KENWOOD

ASB-1044

Service Bulletin

Subject: TS-50S Mechanical Noise from Final Unit

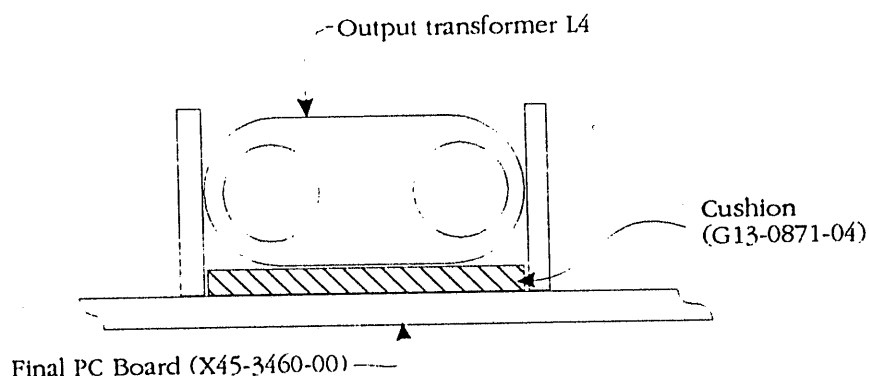
When the transceiver is subjected to vibration a mechanical noise can be heard from the output transformer area. This has led to concern by several consumers that something is loose or improperly installed.

In order to ease consumer concerns you should add a cushion under transformer L4 as shown in the accompanying diagram, and replace transformer L13 at the same time. This transformer has been fastened to the circuit board with high temperature adhesive, so use caution when removing it from the circuit board.

Qty	Description	Old Part No.	New Part No.	Circuit Description
1	Cushion	NA	G13-0871-04	(Under L4)
1	Output Transformer	L39-1209-25	L39-1252-05	L13
